Pana CUSD #8- Lake Land Community Center

10 YEAR HEALTH LIFE SAFETY SURVEY

Lake Land Community Center
600 East First Street
Pana, Illinois 62557

10-year Safety Survey Report

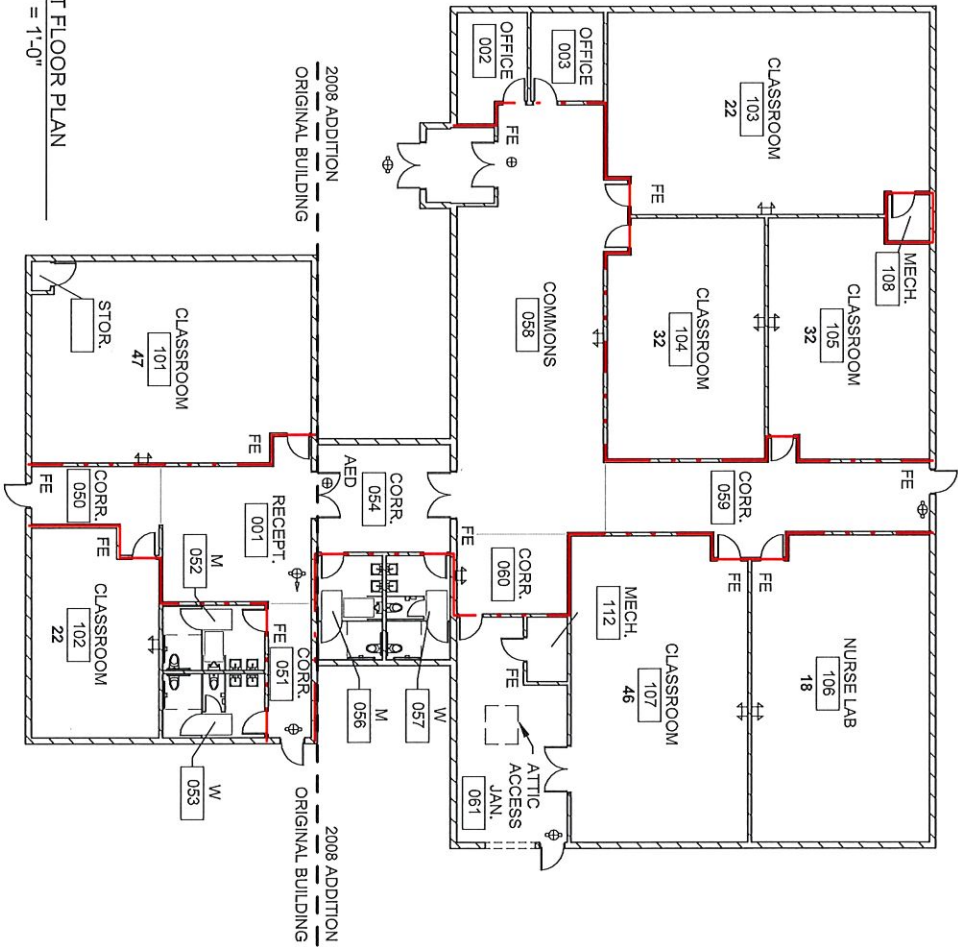
Location/ Rm. #	Priority Code	Rule Violated	Desc. Of Violation	Recommendation to Correct	Action ID	Units of Measure	Qty.	Labor Code	Work Type	Est. Cost	Completion Date	Funding Type
Corridor doors to rooms 003, 103, 104, 106, 107	A. Urgent	IBC 2006 715.4	Doors within exit enclosure do not appear to be labeled and therefore, unless it can be proven otherwise, they lack the 1/3 hour fire protection rating they require. Additionally doors do not have closers installed on them.	Replace existing doors with fire rated doors with closers within existing frames. (20 min rating per table 715.4)	f. Improve	ea	5	2. Contractor	a. Safety Standards	\$ 7,500.00	1/1/2022	O. Other Funds
Corridor doors to rooms 057, 056, 052, 053	A. Urgent	IBC 2006 715.4	Doors within exit enclosure do not appear to be labeled and therefore, unless it can be proven otherwise, they lack the 1/3 hour fire protection rating they require.	Replace existing doors with fire rated doors with closers within existing frames. (20 min rating per table 715.4)	f. Improve	ea	4	2. Contractor	a. Safety Standards	\$ 6,000.00	1/1/2022	O. Other Funds

Entire building	A. Urgent	IBC 2006 715.4	Door in fire rated opening is held open with a wedge	Discontinue use of wedge to hold open door	b. Remove	is	1	District	a. Safety Standards	\$ -	1/1/2022	O. Other Funds
Corridor 051	A. Urgent	IBC 2006 1001.3, IPMC 702.1,	Exterior egress door sticks and does not allow free existing	Adjust door to operate smoothly	f. Improve	ea	1	2. Contractor	a. Safety Standards	\$ 200.00	1/1/2022	O. Other Funds
Classroom 105	A. Urgent	IBC 2006 715.4 IAC 404.2.4.1	Doors within exit enclosure do not appear to be labeled and therefore, unless it can be proven otherwise, they lack the 1/3 hour fire protection rating they require. Additionally doors do not have closers installed on them. Arrangement of door does not comply with Illinois Accessibility Code for maneuvering clearances	Move opening flush with corridor and remove wing wall. Change door swing from left hand reverse to left hand. Replace existing doors with fire rated doors with closers (20 min rating per table 715.4). Patch floor and ceiling at same location and alter wall to meet one-hour fire rating required.	f. Improve	ea	1	2. Contractor	a. Safety Standards	\$ 3,000.00	1/1/2022	O. Other Funds

Office 002	A. Urgent	IBC 2006 715.4 IAC 404.2.4.1	Doors within exit enclosure do not appear to be labeled and therefore, unless it can be proven otherwise, they lack the 1/3 hour fire protection rating they require. Additionally doors do not have closers installed on them. Arrangement of door does not comply with Illinois Accessibility Code for maneuvering clearances	Replace existing doors with fire rated doors with closers within existing altered frame. (20 min rating per table 715.4). Change right hand door to left hand reverse to meet IAC/ADA clearances. The intent to meet figure a and g of 404.2.4.1. Frame will need to be reconfigured in place for new hinge side.	f. Improve	ea	1	2. Contractor	a. Safety Standards	\$ 2,000.00	1/1/2022	O. Other Funds
Mechanical 106	A. Urgent	IBC 2006 1001.3, IPMC 702.1	Door to mechanical room sticks preventing egress from space	Adjust door to operate smoothly	f. Improve	ea	1	2. Contractor	a. Safety Standards	\$ 200.00	1/1/2022	O. Other Funds

Exterior door corridor 059	A. Urgent	IAC	Concrete stoop outside of emergency egress north exit does not meet IAC clearances	Extend concrete pad and ramp	f. Improve	ea	1	2. Contractor	a. Safety Standards	\$ 1,000.00	1/1/2022	O. Other Funds

Entire Building	A. Urgent	96 BOCA F-503.5	This Educational Use Group is not provided with a fire protective signaling system. Occupant load exceeds 50. Building area exceeds 5,000 sq. ft.	Provide a fire alarm system with voice evacuation and ADA compliance. Includes smoke detectors throughout.	f. Improve	sq ft	8,260	2. Contractor	a. Safety Standards	\$ 24,780.00	1/1/2022	O. Other Funds
-----------------	-----------	--------------------	---------------------------------------------------------------------------------------------------------------------------------------------------	------------------------------------------------------------------------------------------------------------	------------	-------	-------	------------------	---------------------	--------------	----------	----------------
